**CONSPAN**  
-SERIES-  
FABRICATION DRAWING

US ROUTE 2  
BRIDGE NO. 126  
TOWN OF LUNENBURG  
ESSEX COUNTY, VERMONT

PROJECT No. 468920	SEQ. No. 010	DATE 12/8/2015
DESIGNED: KDK	DRAWN: TRL	
CHECKED: JDR	APPROVED: PAC	
SHEET NO.: S2 OF S22

**PRECAST UNIT REINFORCEMENT**

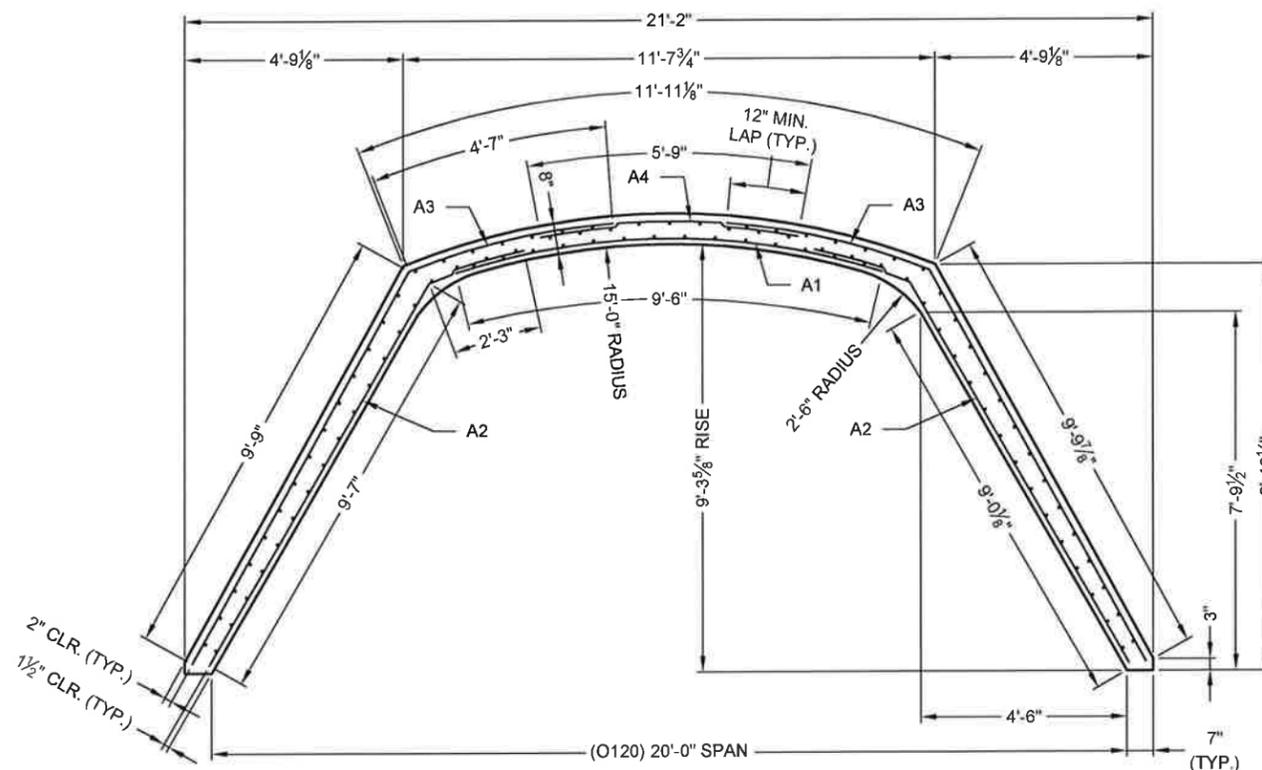
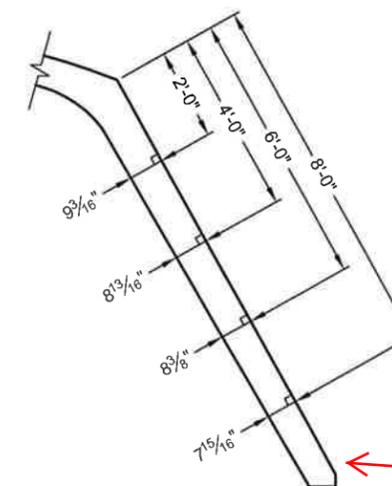
when will curing method/procedure be submitted?  
what is stripping/moving strengths?

assume same thickness down here?

ELEVATION UNIT C1

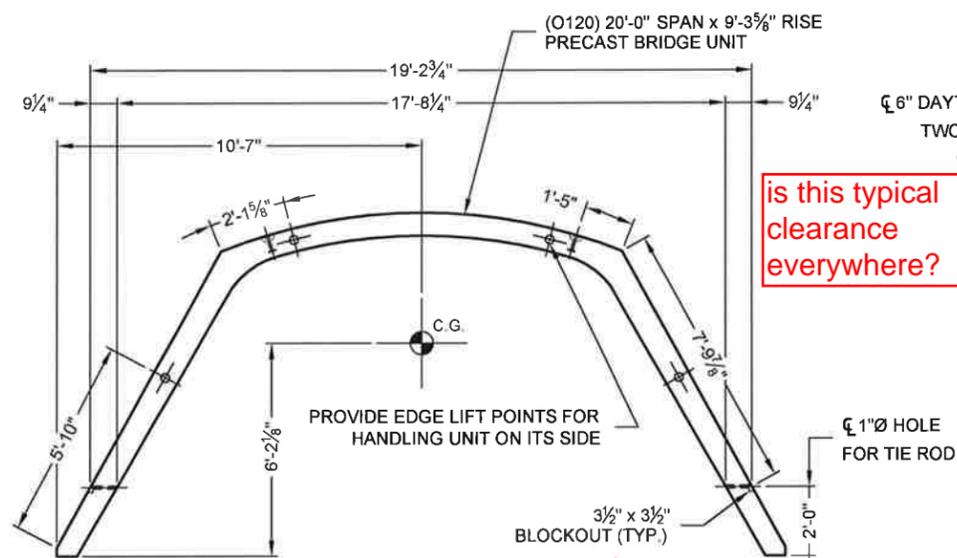
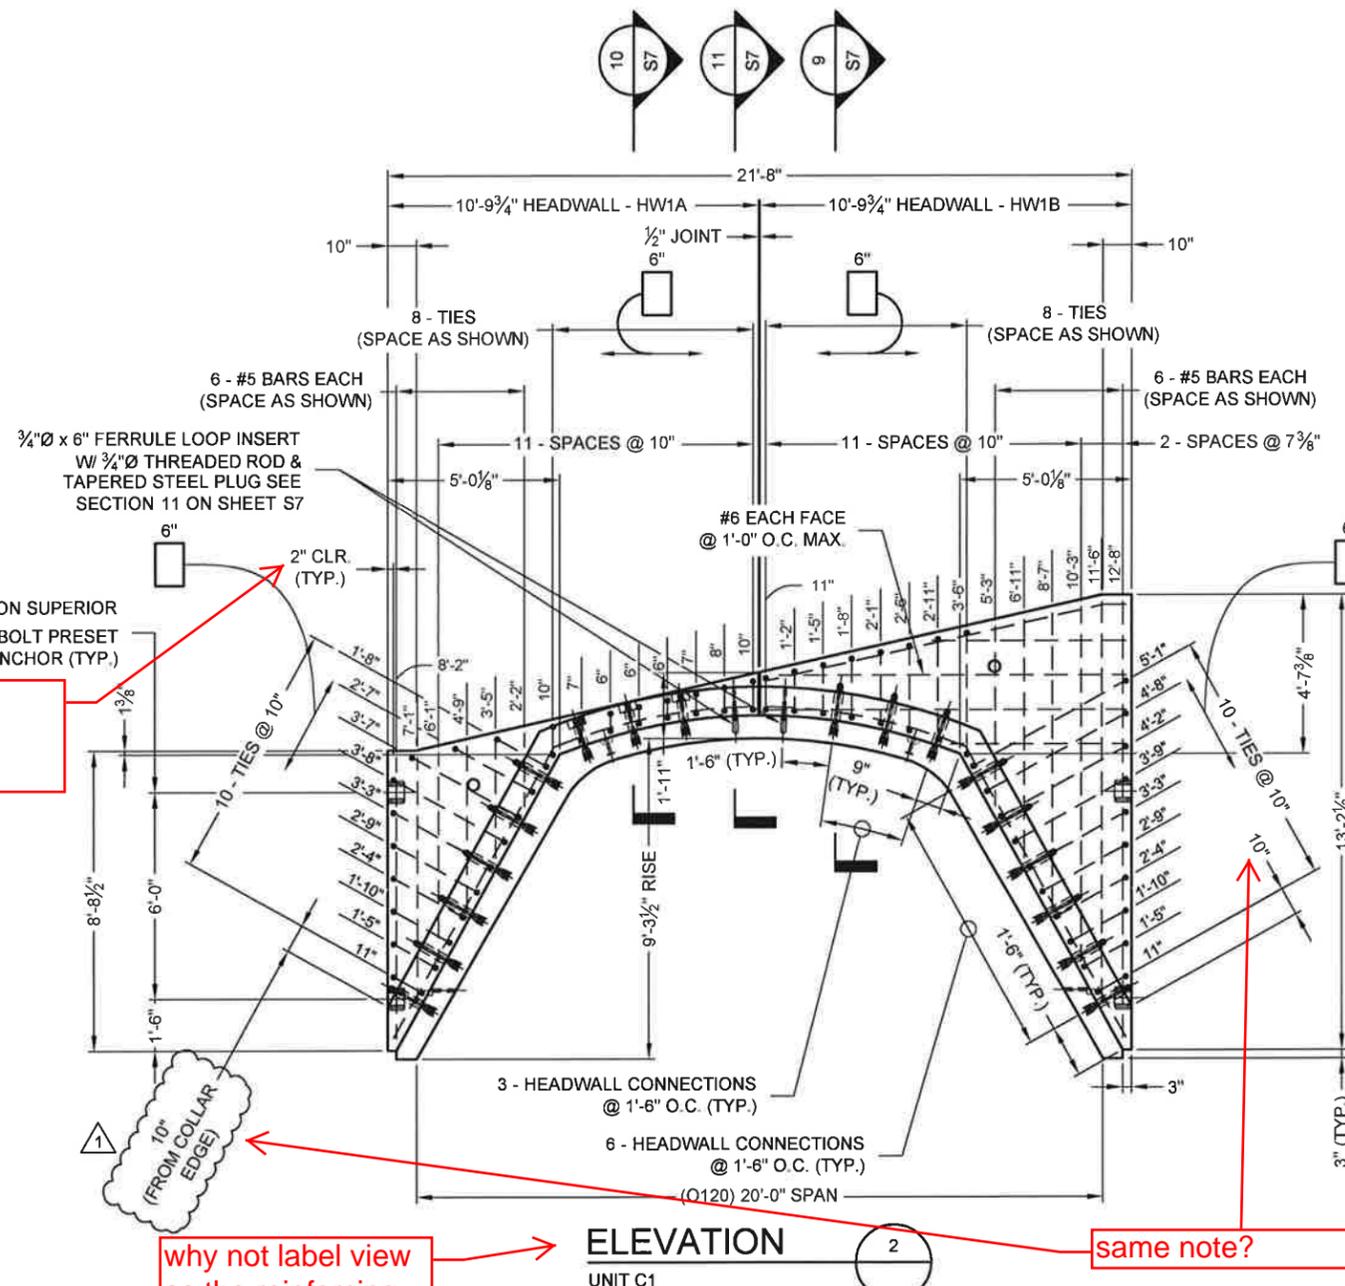
is this typical clearance everywhere?

is there a figure detail for this block out?

why not label view as the reinforcing layout?

same note?

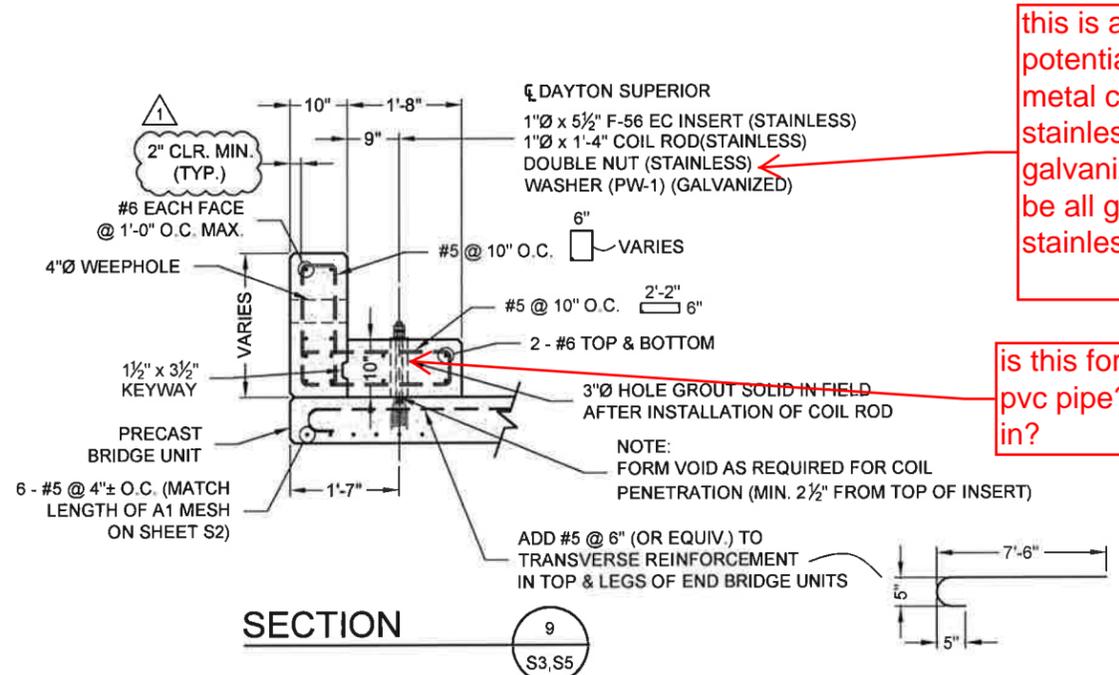
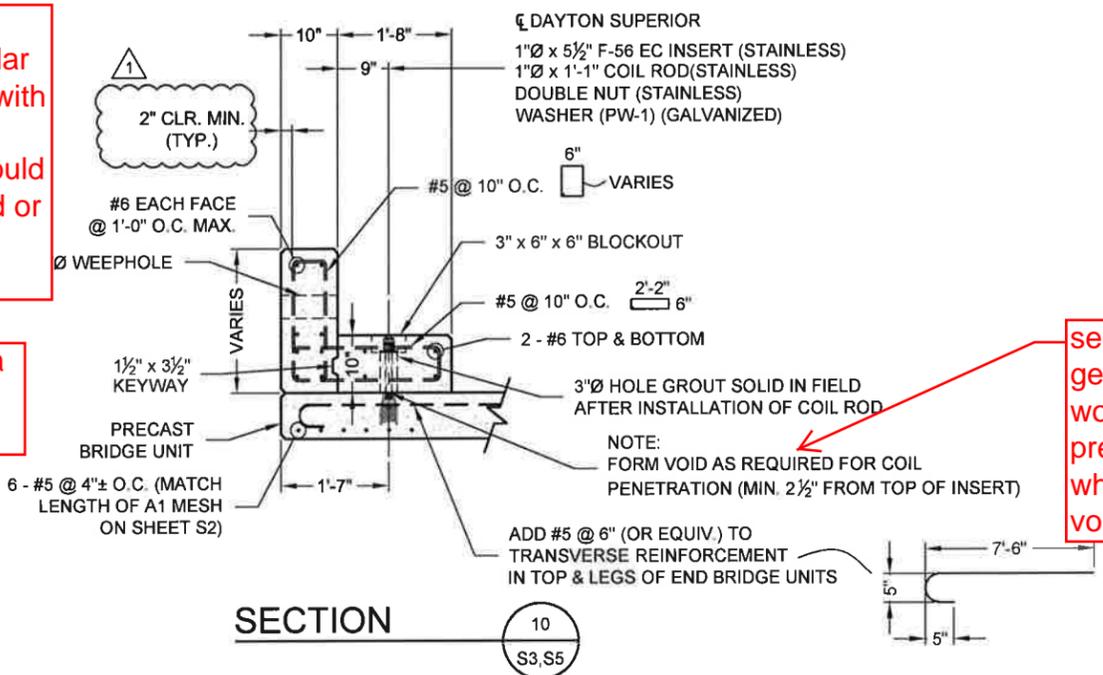
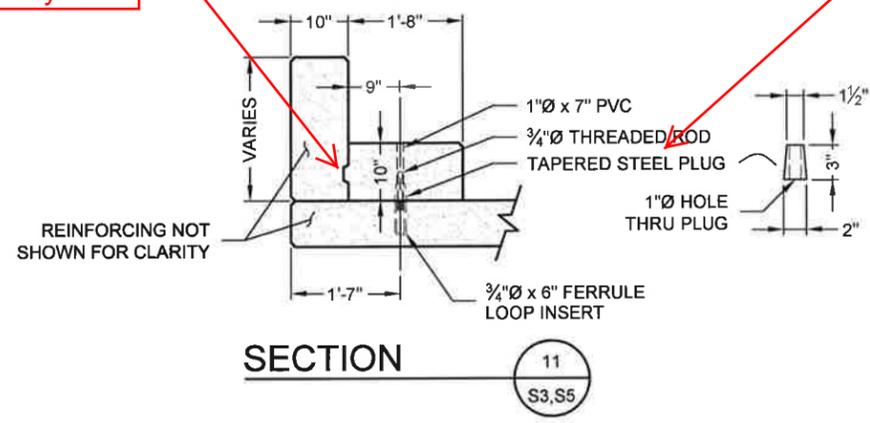
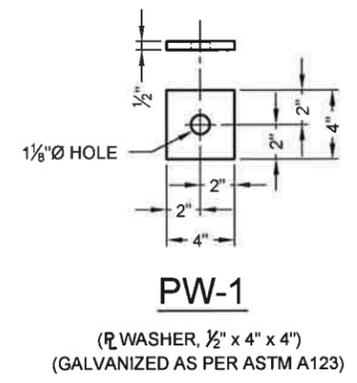
this is a big potential dissimilar metal condition with stainless and galvanized. Should be all galvanized or stainless

is this formed by a pvc pipe? is it left in?

seems kind of general type wording. Shouldn't precaster know what dimension void is needed?

any dimensions for this shear key?

plain steel? not worried of water seepage under head wall and eventually causing that plug to rust?

**REINFORCING DETAIL - WW2A**  
 (FOR ANCHOR REINFORCING SEE SHEET S16 & S17)

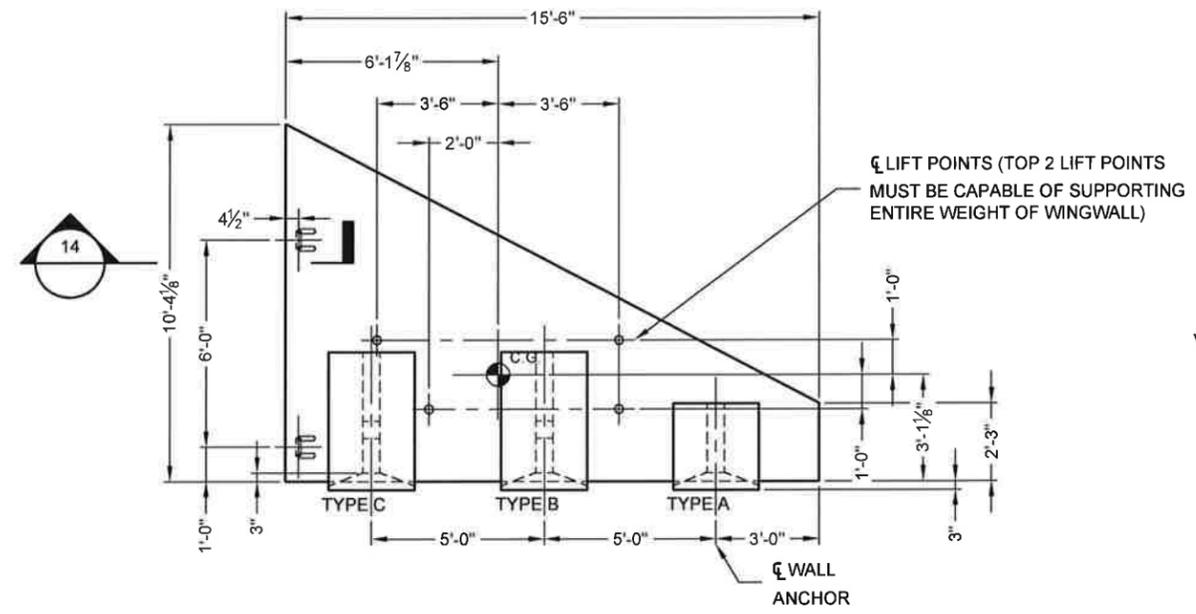
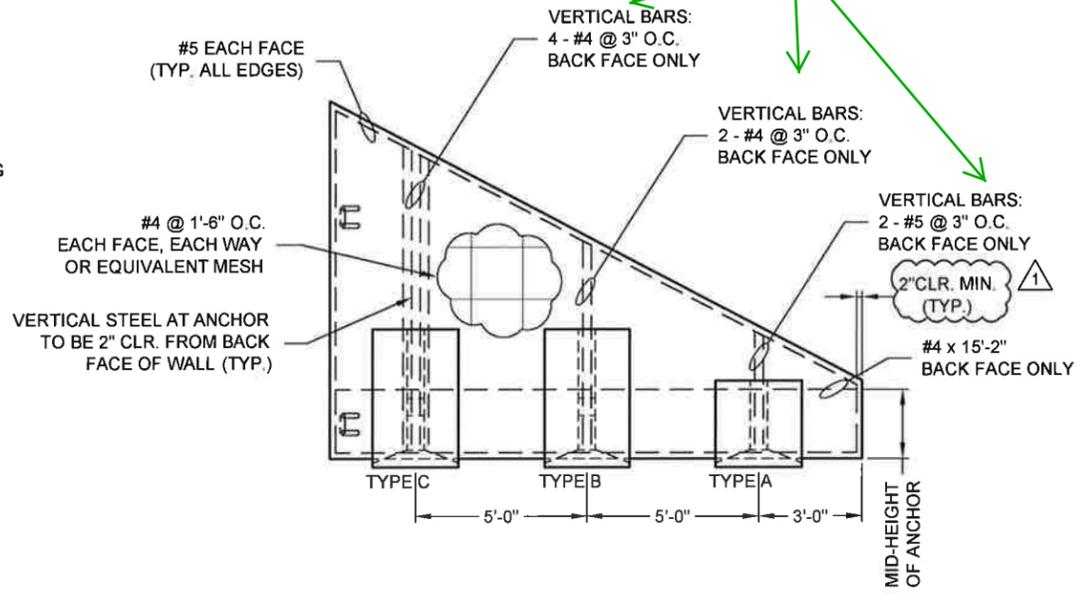
Design calculations were not provided for these vertical bars in the design calculations, please provide.

**REINFORCING DETAIL - WW2B**  
(FOR ANCHOR REINFORCING SEE SHEET S17)

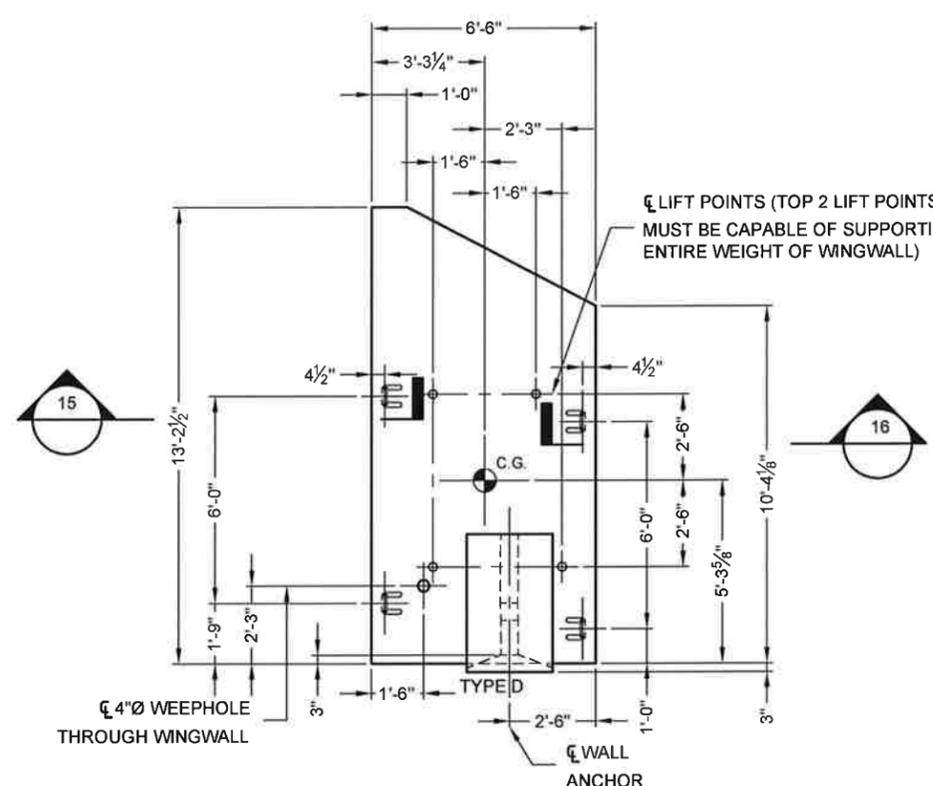
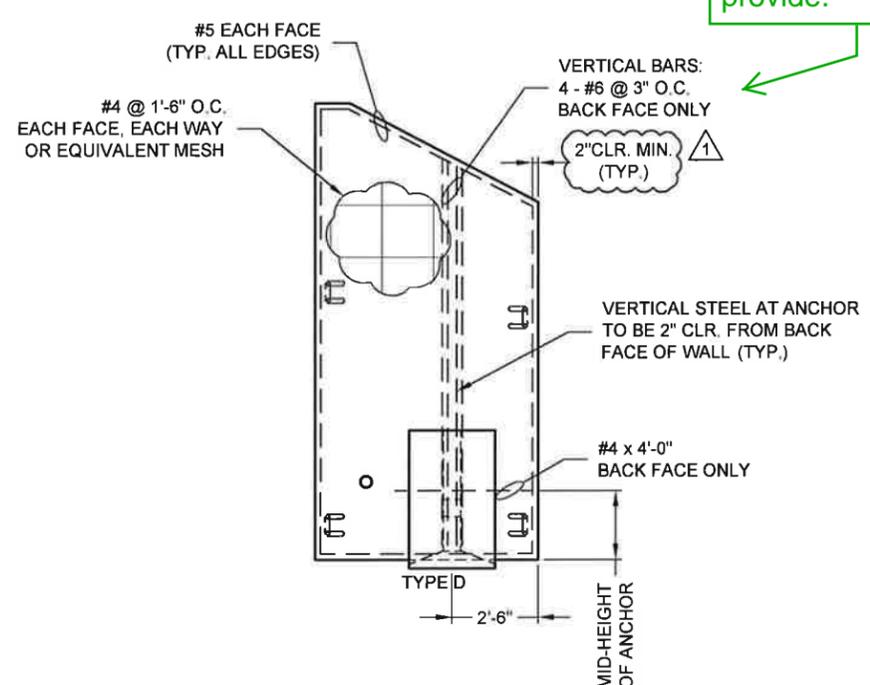
Design calculations were not provided for these vertical bars in the design calculations, please provide.

SECTION - TYPE C  
10" THICK WINGWALL

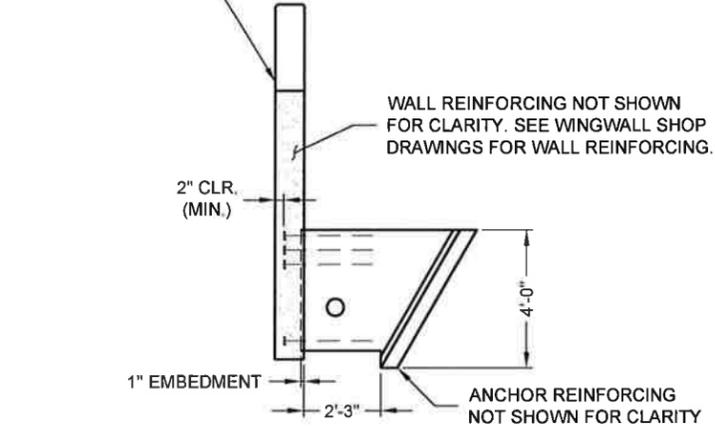
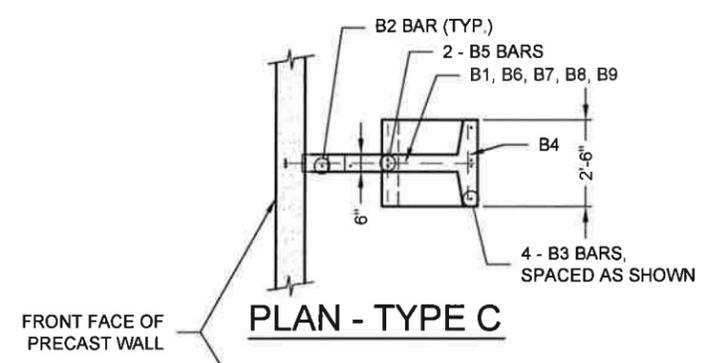
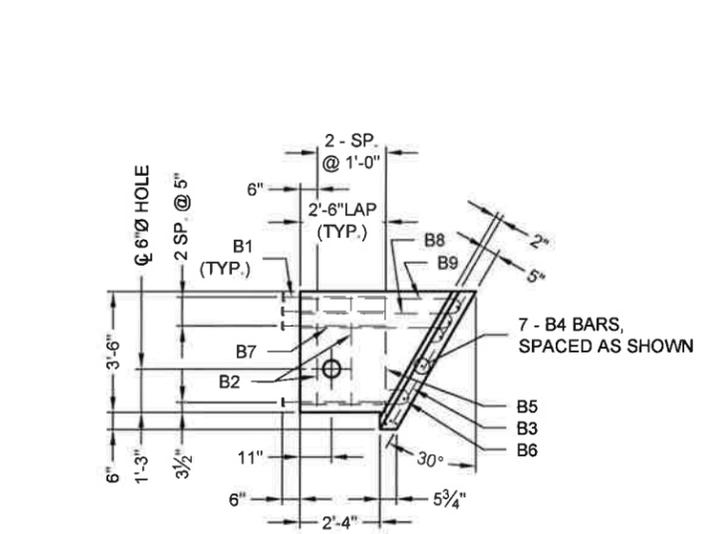
surface should be roughened to give mechanical bond between wall surface and fillet material. what is being used as the "fillet material"?

PRECAST ANCHOR TYPE D  
TOTAL WEIGHT = 1.028 TONS

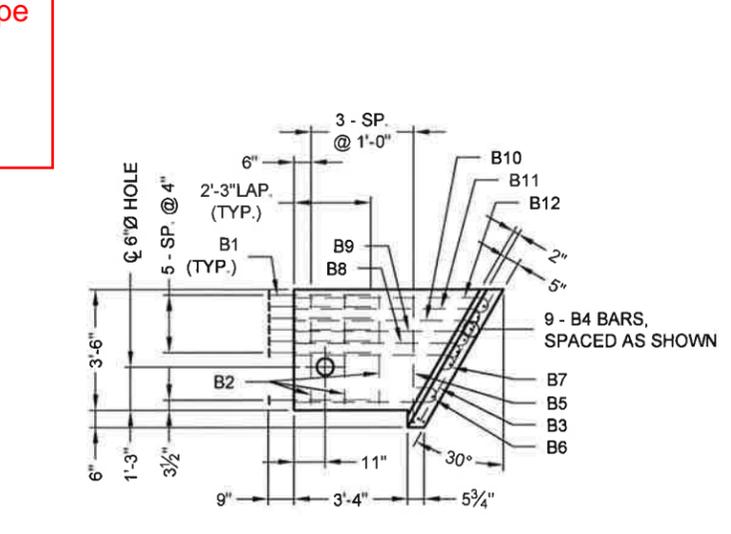
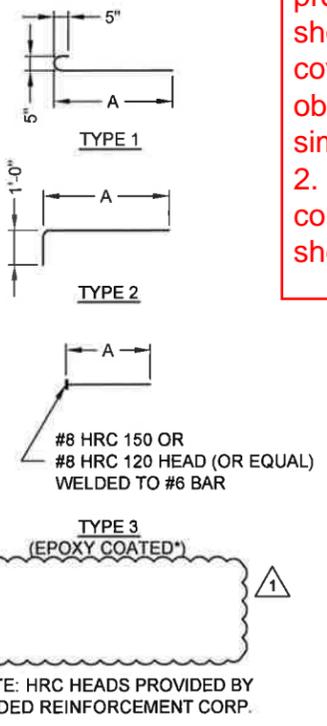
Violates clear specified in note 4.2.3 on sheet S21

Could extra L bars be put in so that the button head protrusion could be shortened so more cover could be obtained? Bars similar to the Type 2. Same comments for sheet 18

**PRECAST ANCHOR TYPE D**

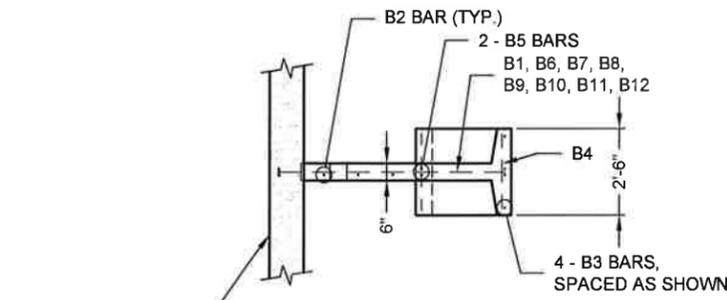
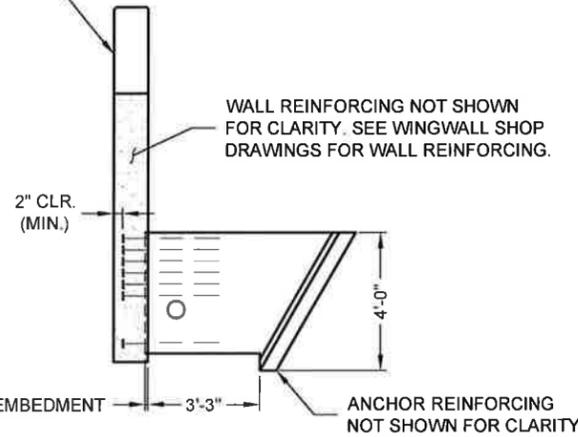
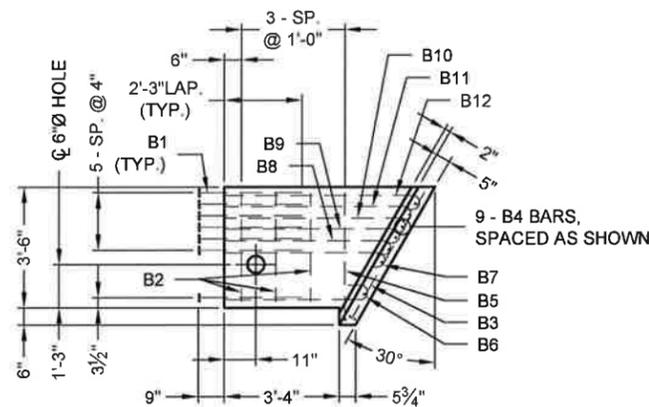
Violates clear specified in note 4.2.3 on sheet S21

**DAYTON SUPERIOR TWO BOLT PRESET ANCHOR**

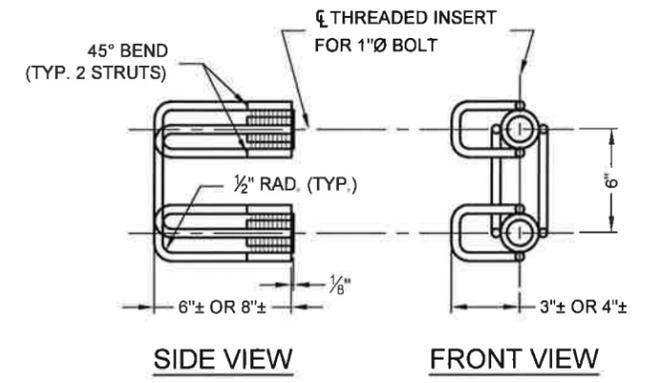
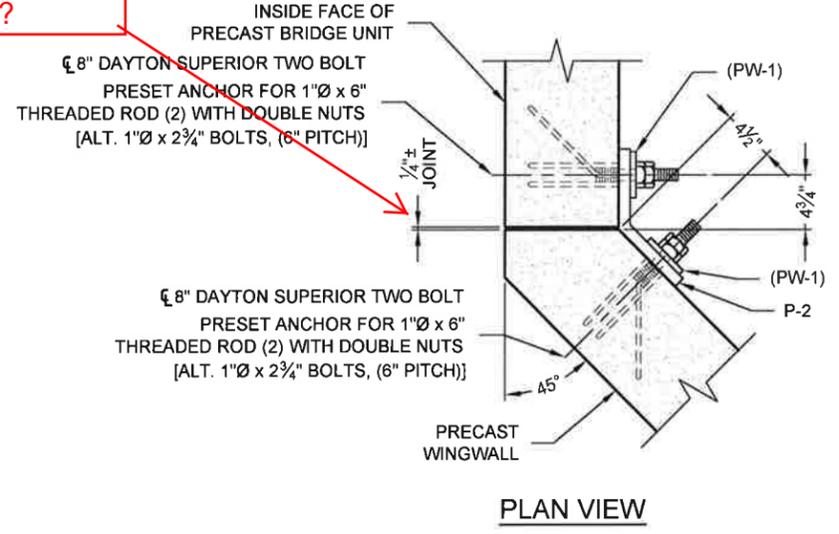
how are these joints being made water tight?
